FMS Upgrade Summary Pegasus 2003

Rob Davis
Flight Deck Crew Ops Integration
Boeing Commercial Airplanes
May 2004

Major changes in PEGASUS 2003

Parallel Entry (Sector 1)

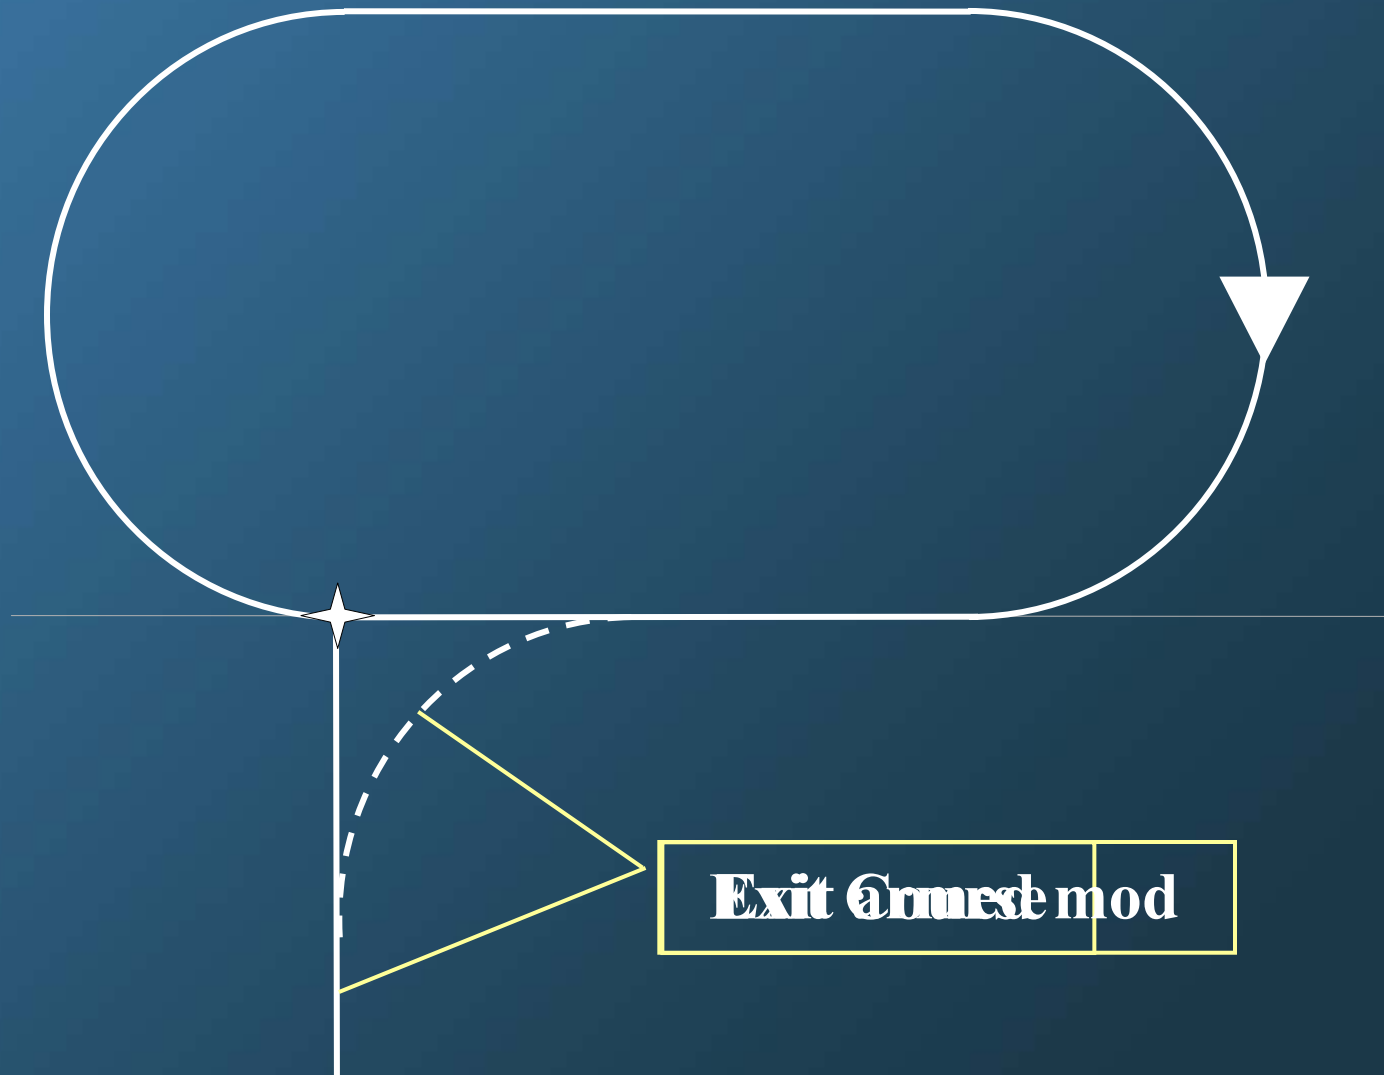
Total redesign of the entry and exit logic

- Flight path (entry and exit) is now displayed on the HSI/ND MAP
 - Entry displayed until established
 - Exit displayed when armed
- Holding fix not treated as “fly-over” waypoint
 - Allows lead turns on entry and exit
 - Keeps maneuvering on the holding side of the fix
- Complies with DO-236 RNP holding

Uplink Delay Timer

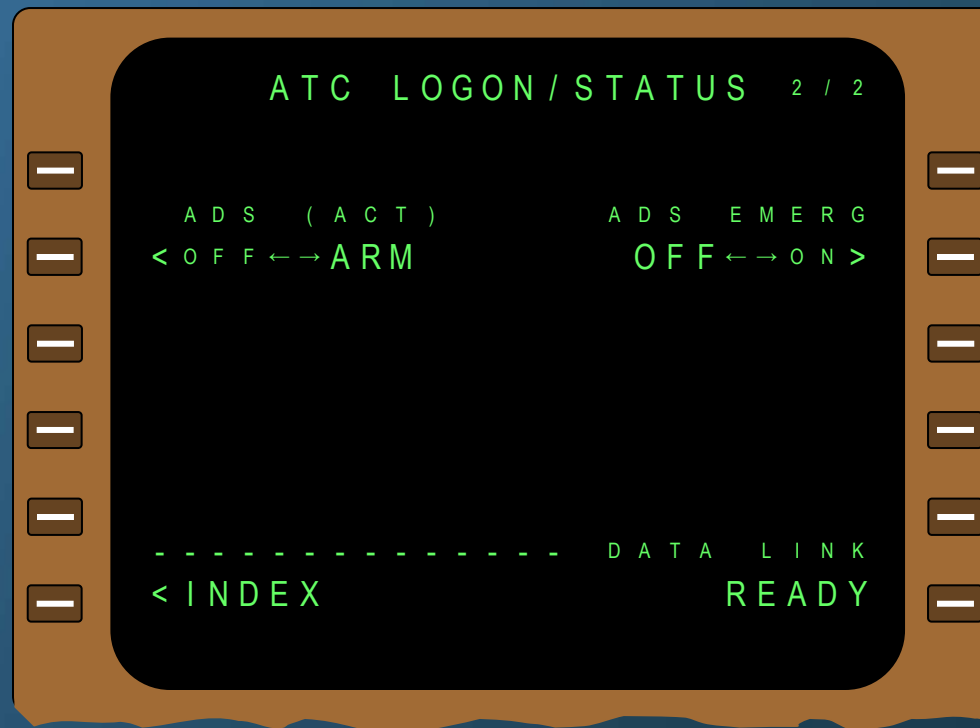
Second page created to make room

“Suspect” ADS Emergency selection moved
